Answer

Digianswer A/S
Skalhuse 5
DK-9240 Nibe

To: Torsten Lohoff, null
From: Joe Dichoso
jdichoso@fcc.gov
FCC Application Processing Branch

Re: FCC ID 020SYN8705A
Applicant: Digianswer A/S
Correspondence Reference Number: 17512
731 Confirmation Number: EA99205

Plot of 20 dB bandwidth in inquiry mode = 547 kHz.

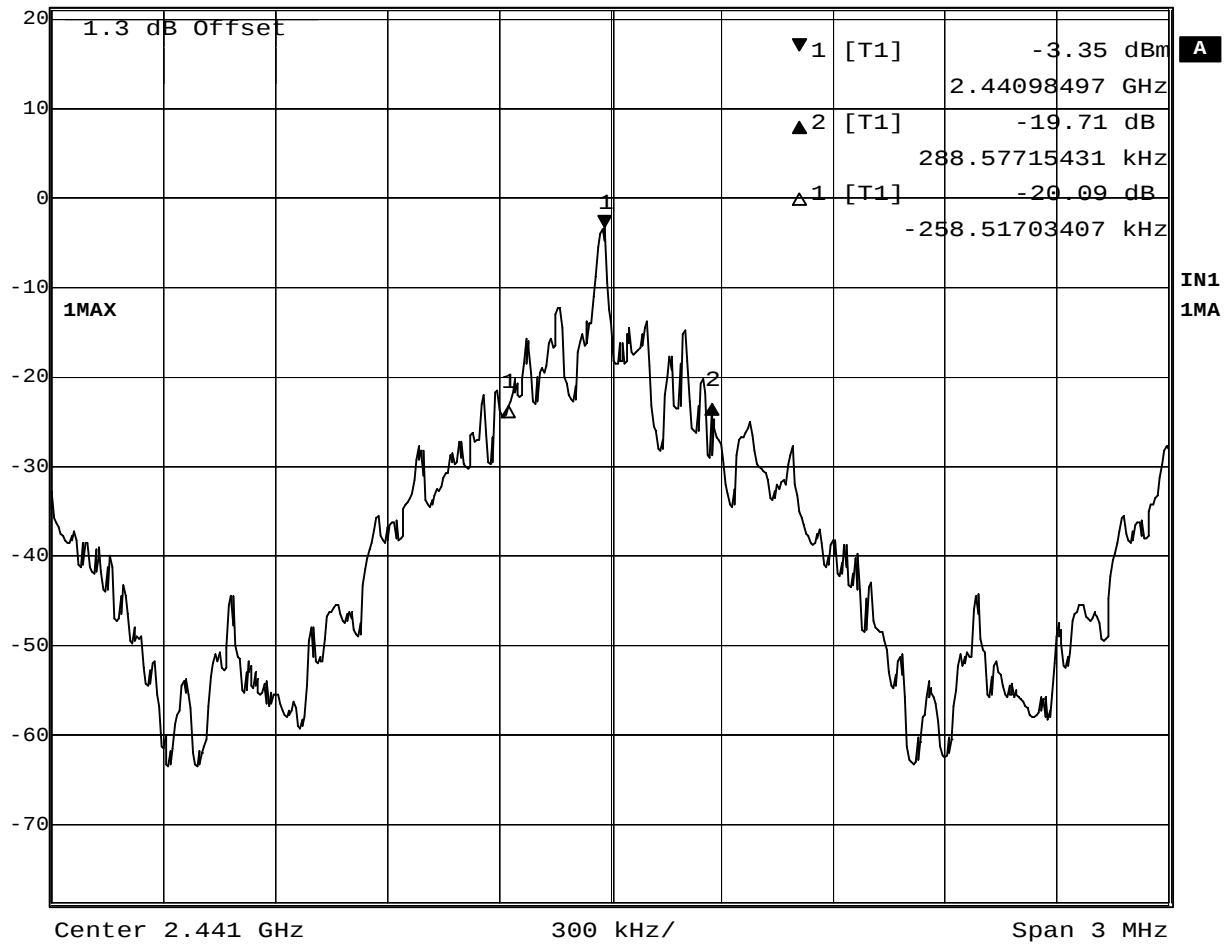
g) 20 dB bandwidth plot.
